From: Hoellman, Jordan
Sent: Monday, June 20, 2016 12:39 PM
To: Vogle PEmails
Subject: IRWST Minimum Screen Area Change and Containment Recirculation Screen Protective Plate Dimension Change - Non-Proprietary slides
Attachments: 2016-06-23 Non-prop slides - Debris Screen Related Dimensions.pdf

IRWST Minimum Screen Area Change and Containment Recirculation Screen Protective Plate Dimension Change (Non-Proprietary)

06/23/2016

Proposed Change

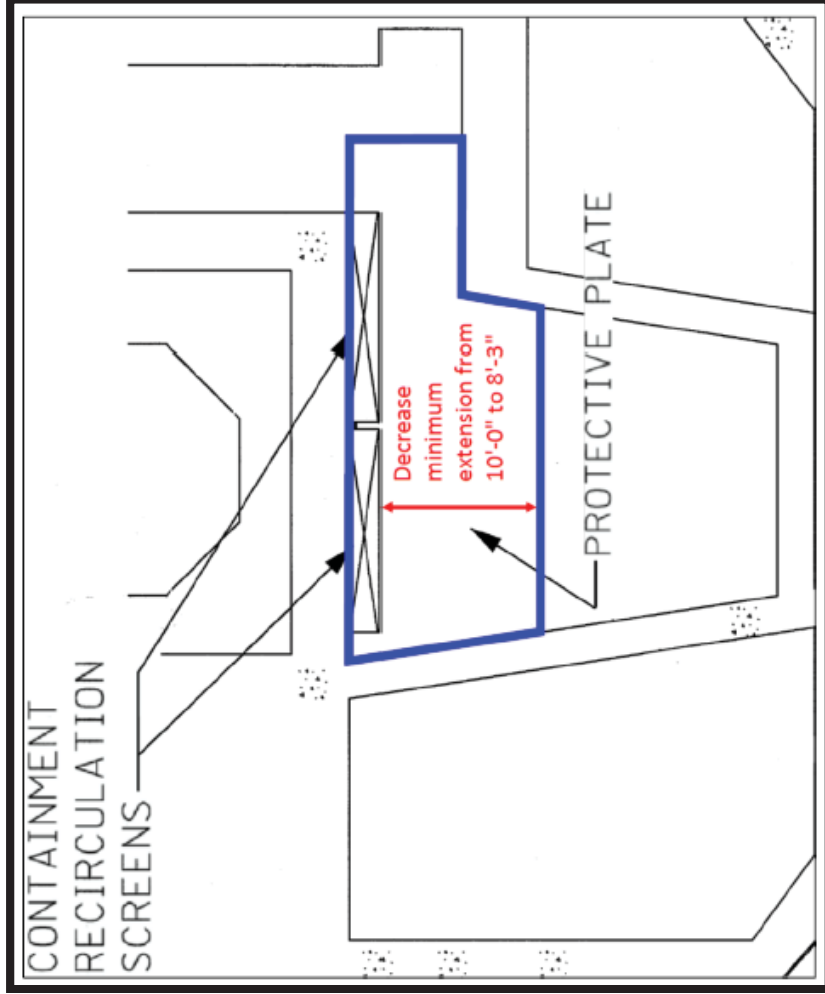
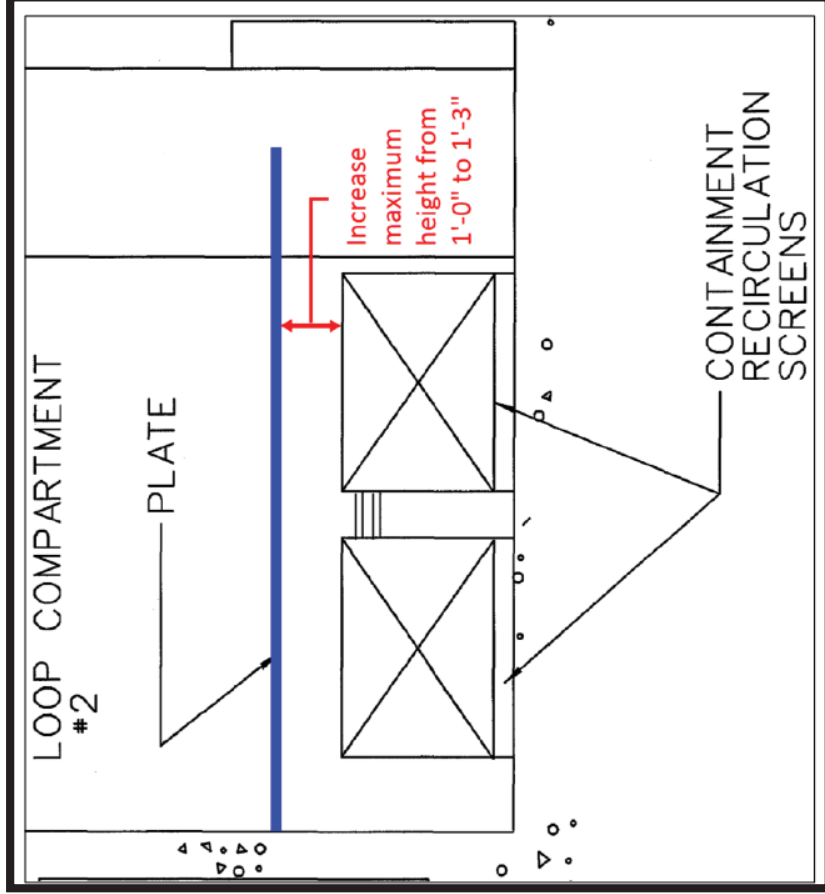
- As identified in UFSAR Subsection 6.3.2.2.7.3, the screen protective plate is provided to prevent nonsafety-related (Service Level II) coating debris that could detach in the post-accident environment from falling too close to the recirculation screens, where it could be transported to the screens.
- The UFSAR currently specifies that the plates located over the containment recirculation screen extend at least 10 feet perpendicular to the side of the screen surface
 - In order to facilitate reactor coolant pump maintenance, additional clearance is proposed in this LAR.
- The UFSAR currently specifies that the plates located over the containment recirculation screen are no more than 1 ft. above the top of the screen.
 - Changes are proposed to clearly specify where the measurements will be taken and account for the final location of the plate

- Specify in UFSAR Subsection 6.3.2.7.3 that the north edge of the north containment recirculation screen face is located at least 3 feet, 6 inches from the north corner of the west wall of steam generator compartment 2
